Service Bulletin

Bulletin No.: 16-NA-020

Subject: Turbocharger Noise and/or Malfunction Indicator Lamp Illuminated with DTC P2261

4367888

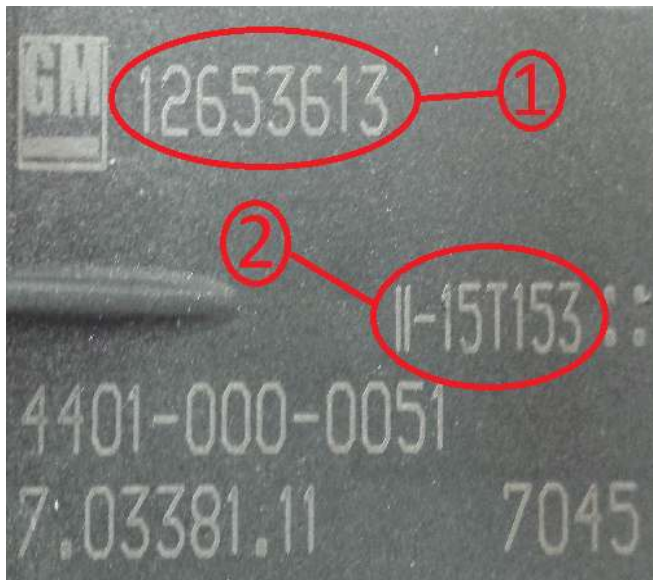
If diagnosis does not lead to an electrical concern, check the Julian date (2) on the turbocharger bypass valve.

- If prior to Julian date 15T327, replace the turbocharger bypass valve per SI repair procedure.
- If the Julian date is 15T327 and after, refer to SI diagnostics.
